Access Compliance Report

Public Rights-of-Way

(Curb Ramps)

Intersection ID: 10024872	Main Street: DEWITT_LN	Cross Street: N/A	Location: SE
ADA ID: 864FFBC8248B	Ramp Type: Perp	Initial Pass/Fail: Fail	Overall Compliance: No
Severity Score: 22.5			
Codes/Mitigation Info/Possible Solution		Field Measurements/Component Compliance

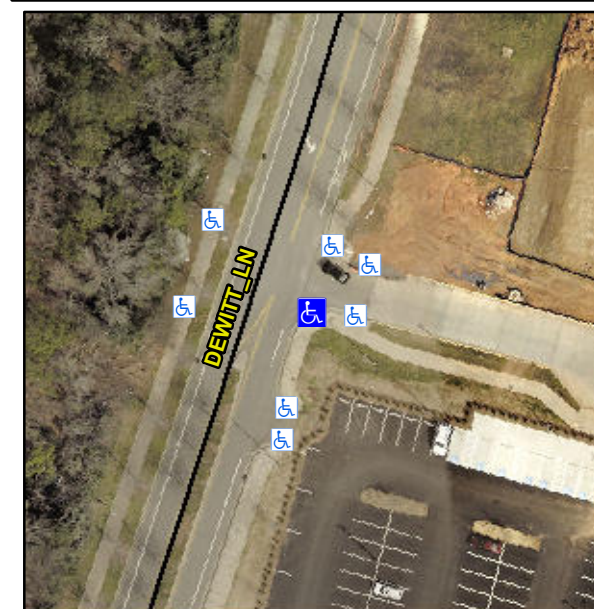
Not Found, R304.5.1, R304.2.2, R304.5.3

Compliance	Description	Data	Compliance	Description	Data
N/A	Ramp Length (in)	96.0	No	Ramp Slope (%)	9.8
No	Ramp Width (in)	46.0	No	Ramp XSlope (%)	3.2
N/A	Flare Type LT	N/A	N/A	Flare Type RT	N/A
N/A	Flare Slope LT (%)	N/A	N/A	Flare Slope RT (%)	N/A
N/A	Flare Traversable LT?	N/A	N/A	Flare Traversable RT?	N/A
N/A	Landing Length (in)	N/A	N/A	DWS Provided?	N/A
N/A	Landing Width (in)	N/A	N/A	DWS Contrast?	N/A
N/A	Landing Slope (%)	N/A	N/A	DWS Length (in)	N/A
N/A	Landing X Slope (%)	N/A	N/A	DWS Full Width?	N/A
N/A	Landing Curb? (Y/N)	N/A	N/A	DWS Offset (in)	N/A
N/A	Shared Landing?	N/A			
N/A	Gutter Ponding?	N/A	N/A	Gutter Slope (%)	N/A
N/A	Gutter Lip Ht (in)	N/A	N/A	Gutter X Slope (%)	N/A
N/A	Painted X Walk1?	No	N/A	Painted X Walk2?	N/A
	X Walk 1 Direction	To W		X Walk 2 Direction	N/A
N/A	X Walk 1 Width (in)	N/A	N/A	X Walk 2 Width (in)	N/A
	X Walk 1 Slope (%)	0.5		X Walk 2 Slope (%)	N/A
	X Walk 1 X Slope (%)	1.3		X Walk 2 X Slope (%)	N/A

Remove & Replace Entire Ramp.
